United Nations ECE/TRANS/WP.29/2018/41

Proposal for Supplement 4 to the 01 series of amendments to UN Regulation No. 129 (Enhanced Child Restraint Systems)

Supplement 4 to the 01 series of amendments to UN Regulation No. 129 (Enhanced Child Restraint Systems)

"Figure 3

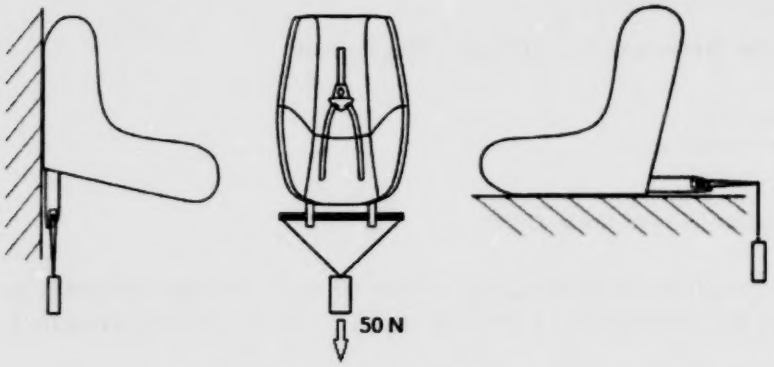
Paragraph 7.2.8., amend to read:

Figure 3, amend to read:

"7.2.8. The complete seat, or the component fitted with ISOFIX attachments (e.g. ISOFIX base) if it has a release button, is attached rigidly to a test rig in such a way that ISOFIX connectors are aligned as shown in Figure 3. A 6 mm diameter bar, 350 mm long, shall be attached to the ISOFIX connectors. A force of 50 ± 1 N shall be applied to the extremities of the bar."
